North Hertfordshire District Council
Building Conservation comments

File Ref: 18/00331/FPH
Date: 06/03/2018
Planning Officer:
Address: Dibble Cottage, School Lane, Barley
Subject: Single storey side extension following demolition of existing conservatory. Single storey first floor rear extension and porch following demolition of existing rear porch. Single storey front porch extension following demolition of existing porch.

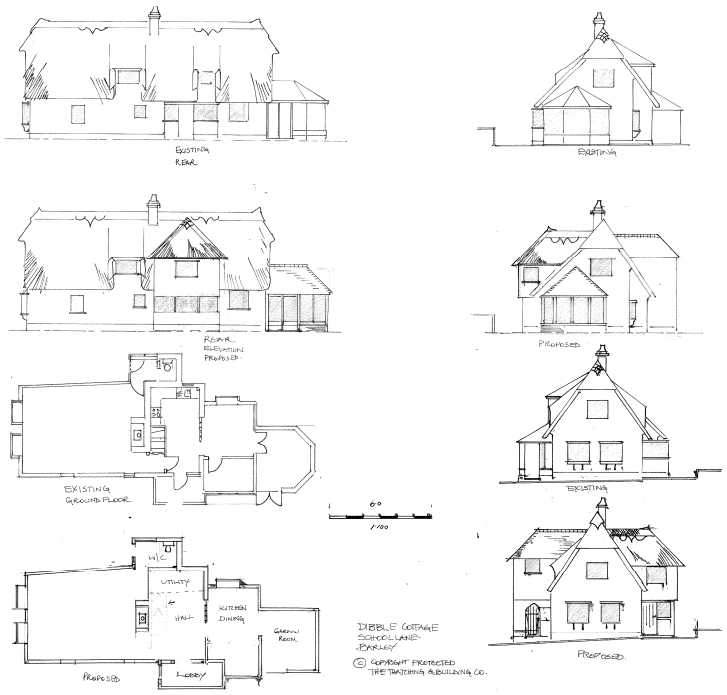
Finally, I am willing to support a tiled replacement garden room along the lines suggested below:
